COUNTY OF SAN MATEO
PLANNING AND BUILDING DEPARTMENT

RECOMMENDED FINDINGS AND CONDITIONS OF APPROVAL

Permit File Number: PLN 2014-00409

Board Meeting Date: November 17, 2015

Exhibit A: *Marked-up Sheets T1 & A6*

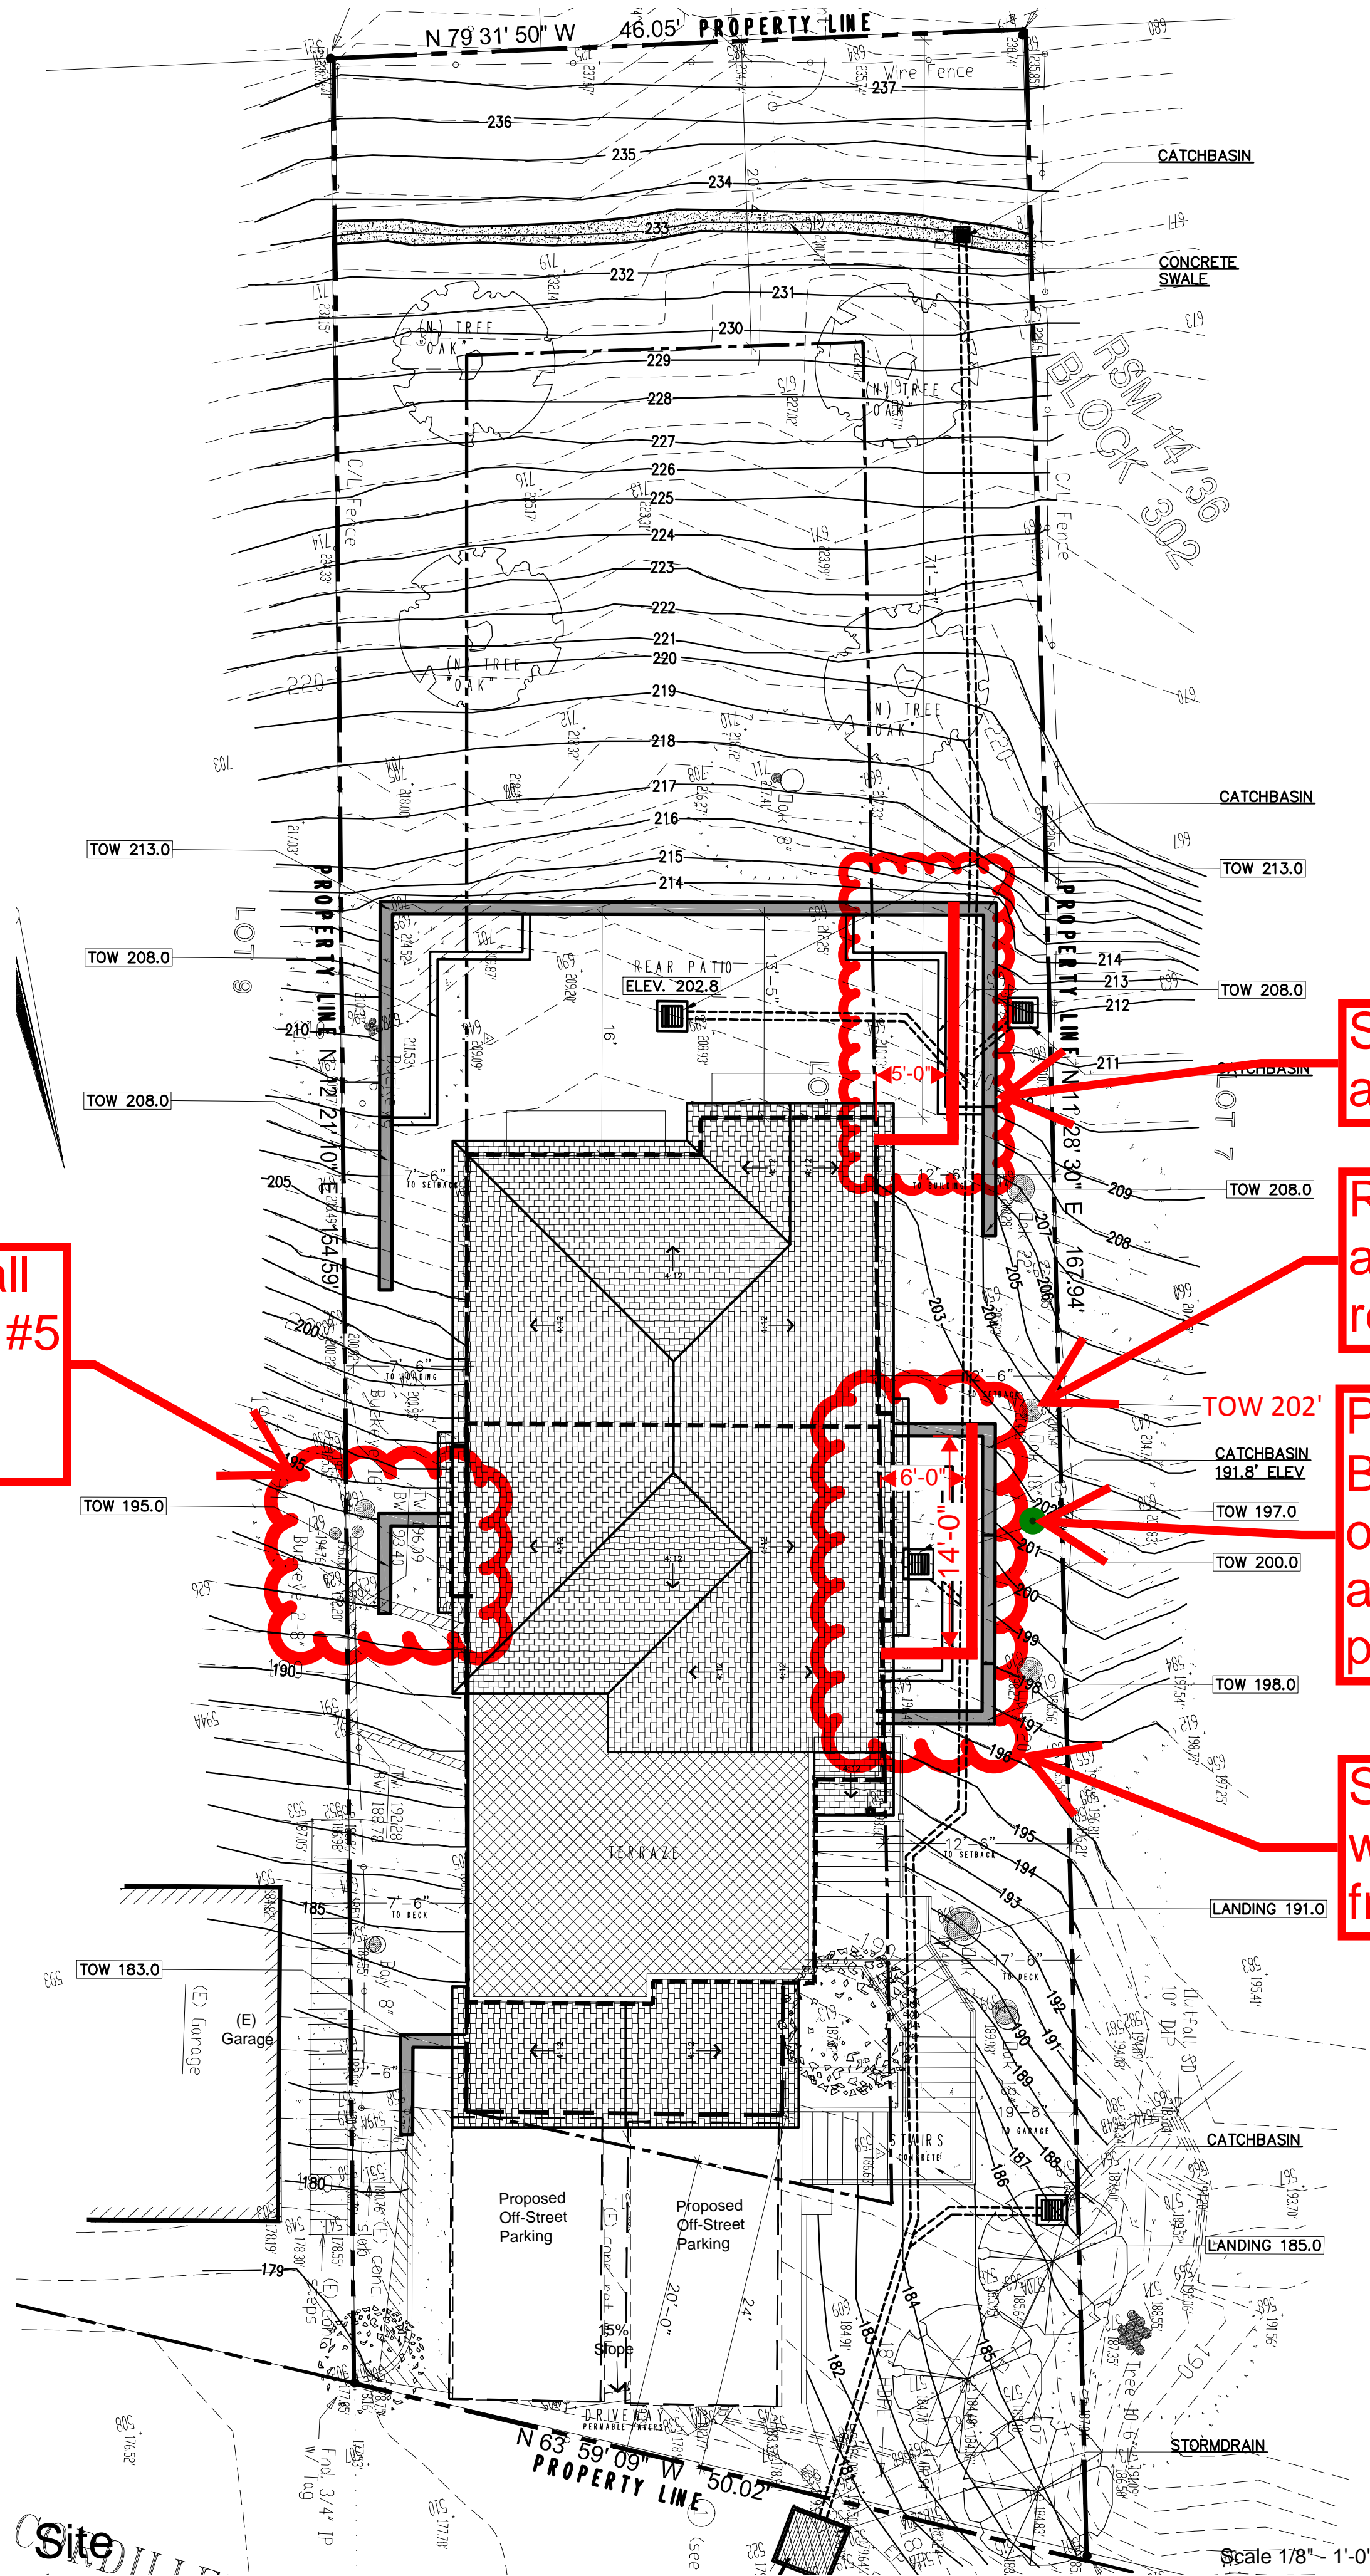
Remove retaining wall to save trees #4 and #5 to address neighbor privacy concern.

Shift retaining wall away from tree #6.
